BD Micro Series Base Plate Earth Hole Position Modification

Fig. 1 Earth hole position

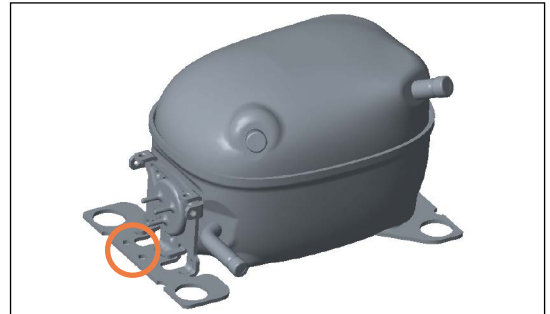
Until now, Secop offered its BD Micro series with an earth hole in the center of the left side base plate on all BD1.4F-AUTO/VSD/FSD, and PBC compressors (see figure 1).

As the screwdriver accessibility to the center hole is pretty limited, we will add another 15 mm next to the original one (see figure 2) and on the opposite base plate (see figure 3).
